August 20, 2008

Subject: Responses to Request for Additional Information (RAI) on the Amendment Application for CoC No. 9225 for the NAC-LWT Cask to Incorporate PWR Mixed-Oxide (MOX) Fuel Rods as Authorized Contents (TAC L24181)

Docket No. 71-9225

Figure 5-4.1 VISED Sketch of Discrete Pin Model

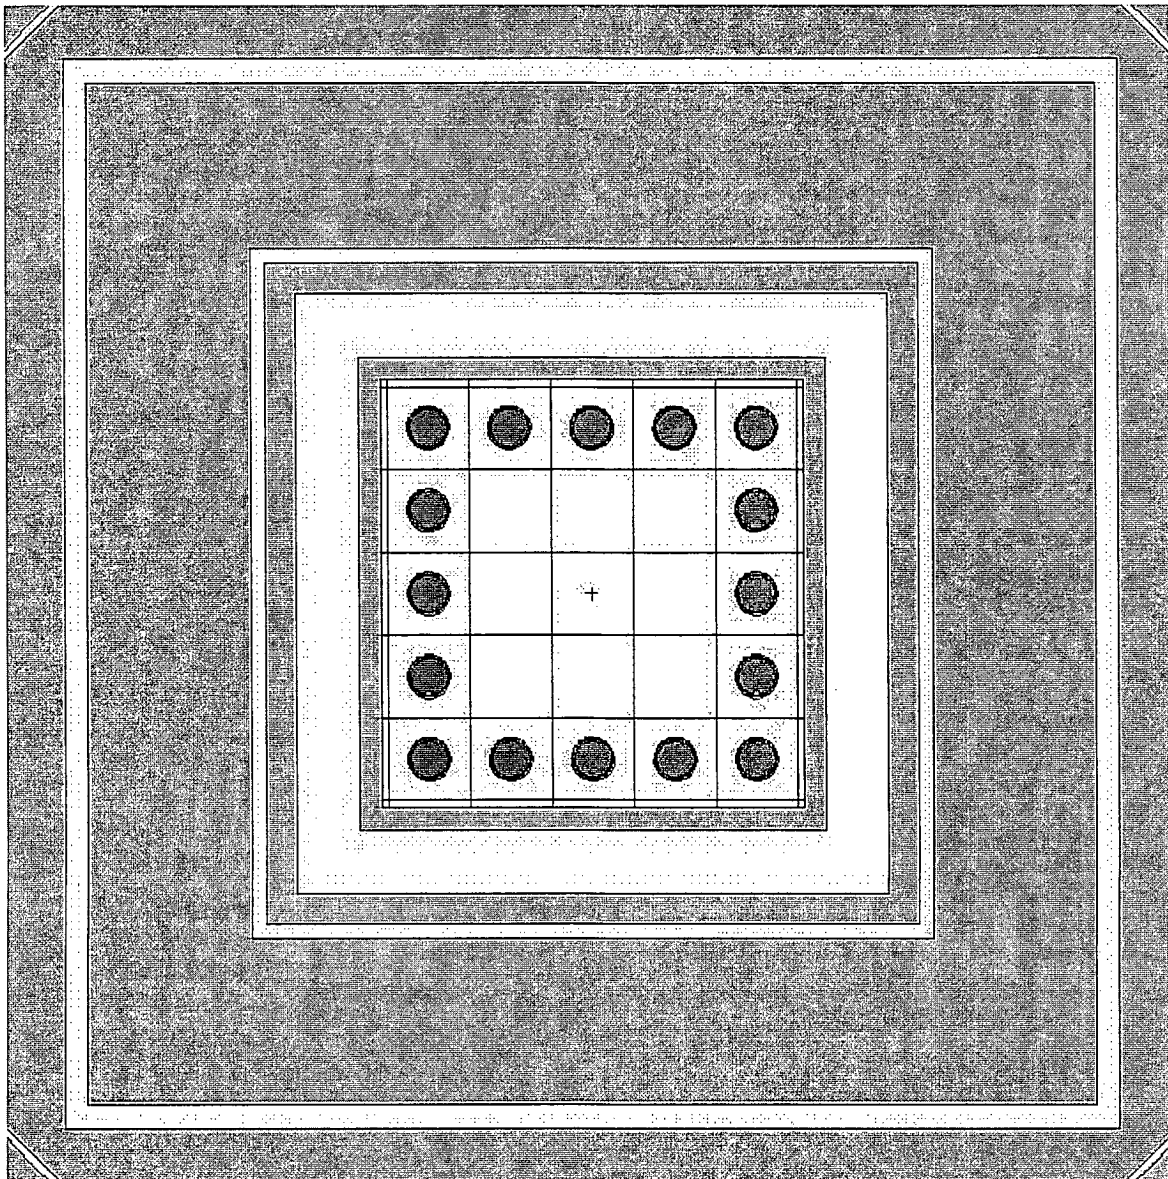
To address concern that an exterior (outer layer) placement of 16 rods may produce higher dose rates, a revised shielding model explicitly placing the 16 minimum fuel mass fuel rods in the outer insert slot locations is evaluated. A VISED sketch of the revised cask internal model is shown in Figure 5-4.1. As shown in Table 5-4.1, for a sample 80 GWd/MTHM, 90-day cooled source, the discrete model produces lower dose rates than the homogenized source model. Reduced dose rates are the result of the high-density fuel rod actually providing more shielding for the now-compacted source region than the homogenized source. The SAR analysis model description in Section 5.3.18.2 and results in Section 5.3.18.3 are revised to include the additional model description and dose comparison.

Figure 5-5.1 VISED Sketch of Discrete Pin Model – Mixed Loading

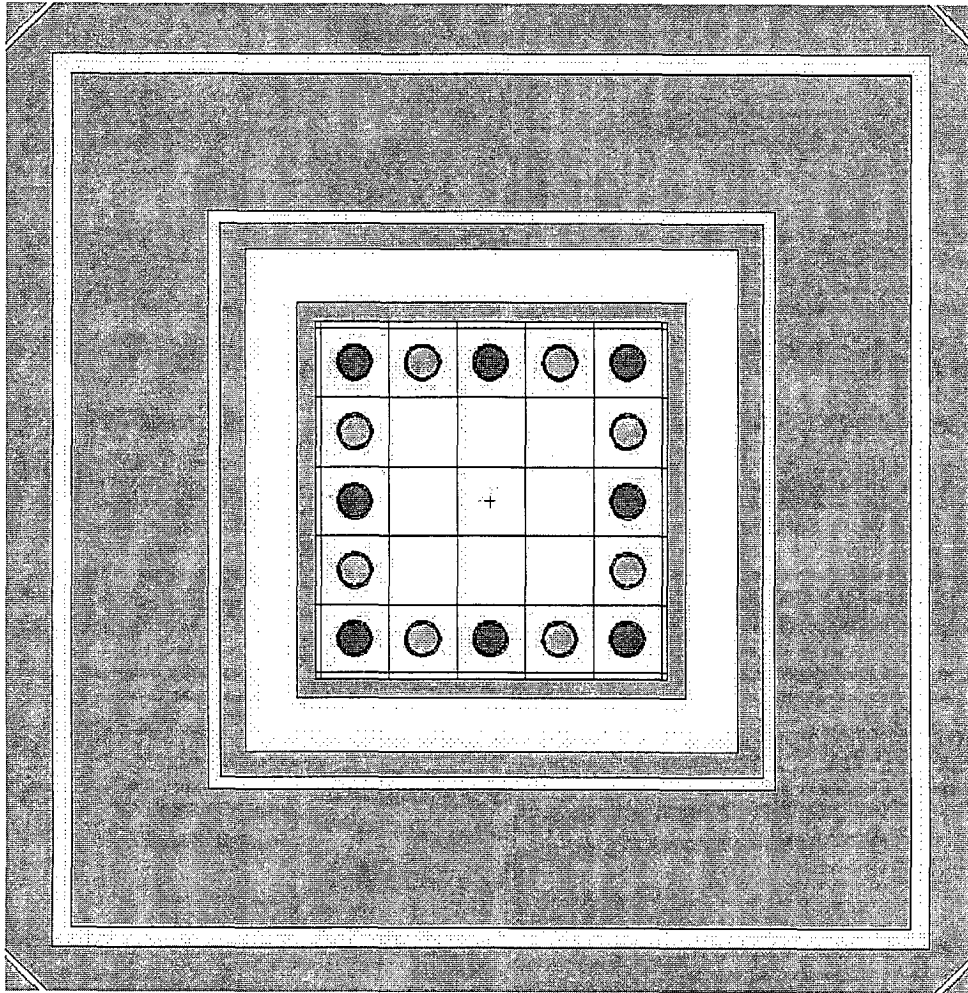
On page 5.3.18-3 of the SAR, the applicant states: "The combination of 16 fuel rods, either UO₂ or MOX fissile material based, are loaded into a 5 × 5 tube array insert constructed from stainless steel. ... The 16 rods are homogenized within the cross sectional area of the canister spacer." It is not clear, however, how the rods with different material compositions are homogenized. The staff's review of the sample input file, Figure 5.3.18-5, "Sample MCNP Input File for PWR MOX Fuel (Response Method Benchmark Case)" found that the composition of material with material ID card 1 is for pure UO₂ fuel rather than MOX fuel as the title of the figure indicates. It is not clear which model produced the results presented in Table 5.3.18-14 and Table 5.3.18-15.

To address the concern that this information is insufficient to address regulatory compliance, NAC added evaluations of the discrete pin model with a mixed loading of eight UO₂ and eight MOX rods. A VISED sketch of this geometry is included in Figure 5-5.1. Analysis results demonstrating that there is no effect of mixing materials are included in Table 5-5.1. The results of these evaluations are included in SAR Section 5.3.18.3, revised in response to this RAI. Also included in the SAR is a sample MOX input file for the mixed fuel loading (Figure 5.3.18-9).

Figure 5-6.1 Comparison of Direct Solution and Response Function Results at Cask Surface for Normal Conditions Model for Discrete Rod Mixed Loading of 8 UO₂ Rods and 8 WG Rods

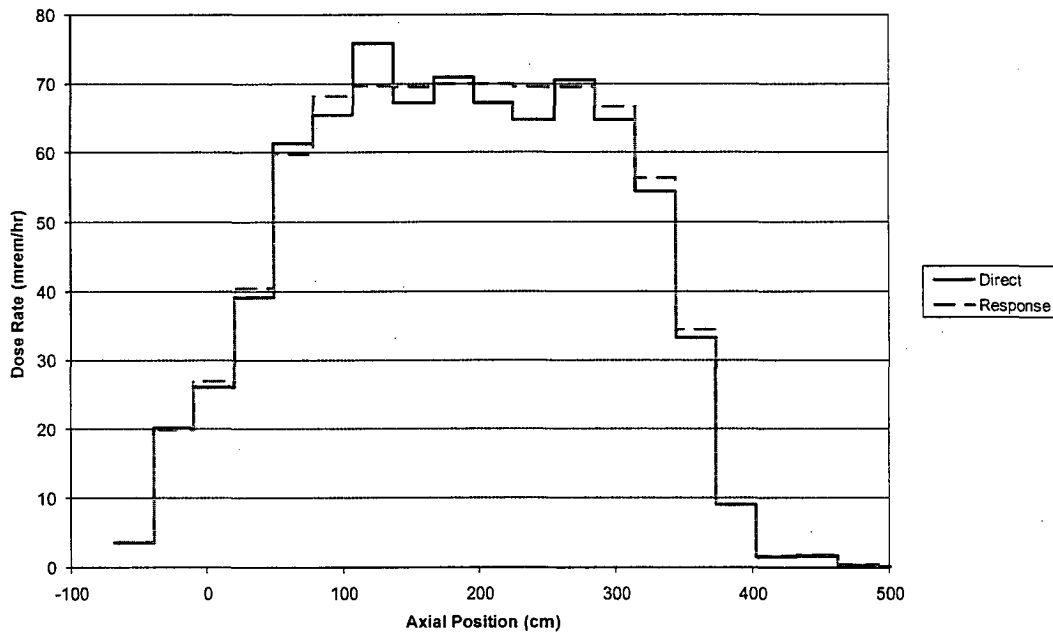
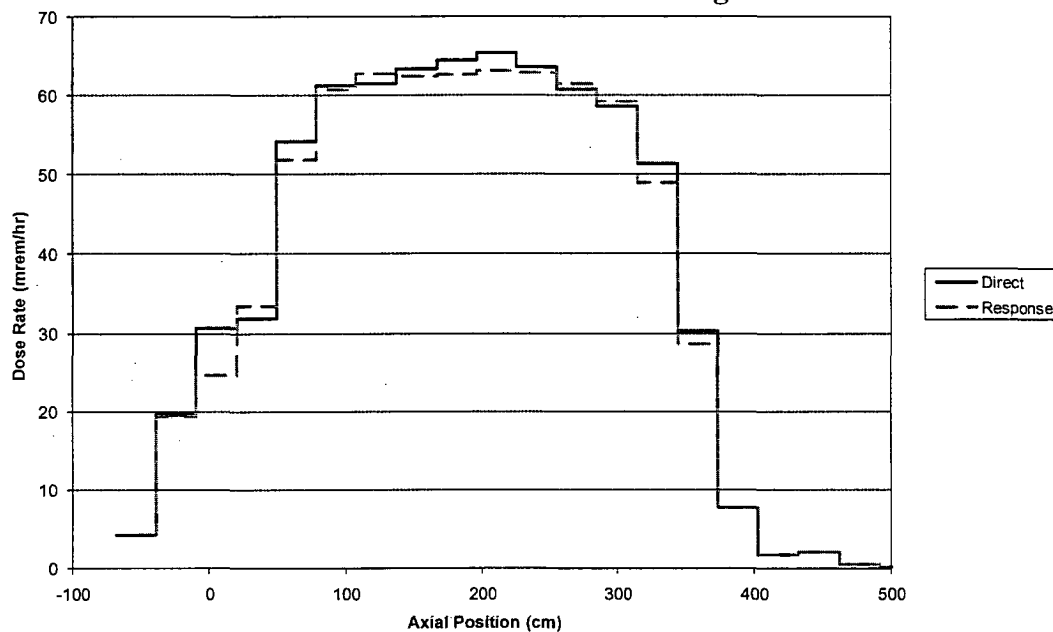
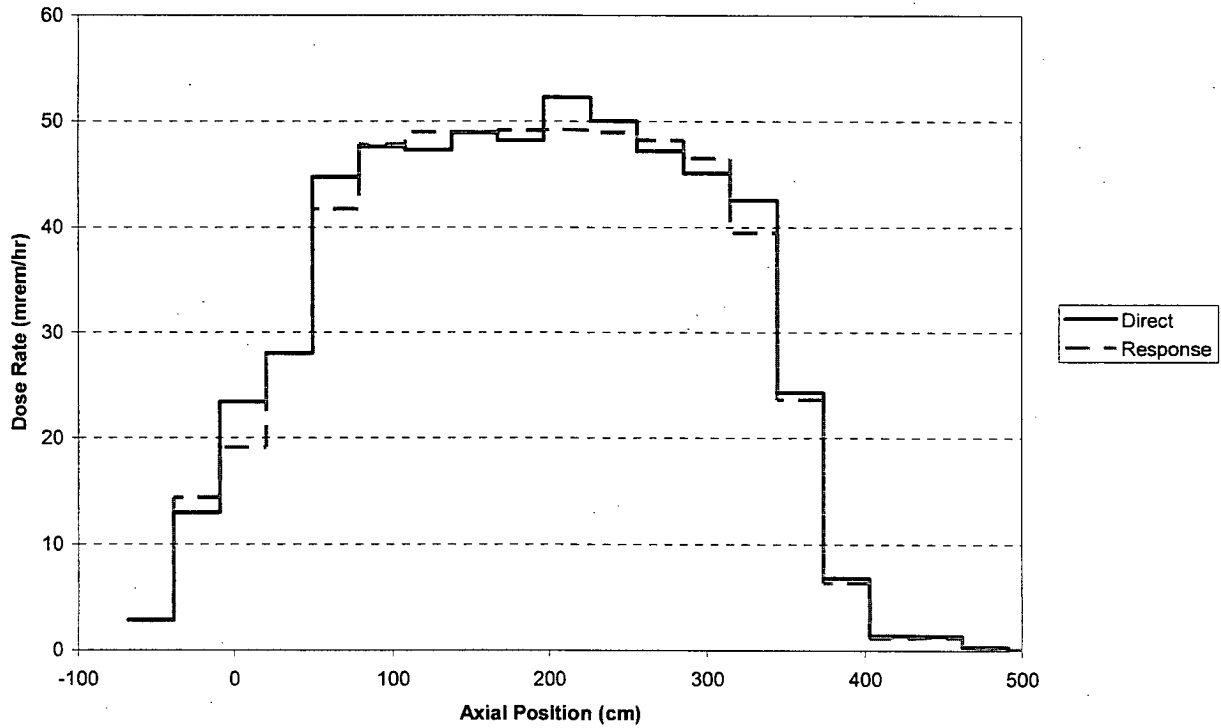
On page 5.3.18-4 of the SAR, the applicant states: "A sample input file is provided in Figure 5.3.18-5. The sample input provides a complete source description used in the response function benchmark analyses." As this approach completely decoupled the dependence of the particle transport to the material composition of the media that the particles traverse and interact with, the reliability and the accuracy of this approach can be assessed only on a case-by-case basis. It is especially true for MOX fuel because of the large cross sections of the fission, (n, 2n), (gamma, n), (n, gamma), and (n, alpha) reactions and the secondary radiation generated by these nuclear reactions.

are based on the discrete fuel rod model to allow mixed fuel to be explicitly accounted for. Results of the comparisons are shown in Figures 5-6.1, 5-6.2 and 5-6.3, and demonstrate that the results of the response and direct solutions are equivalent, independent of the source modeling employed (i.e., discrete fuel rods or homogenized). Differences between response method and direct calculation results are associated with significantly higher statistical uncertainties produced by the direct calculation approach.
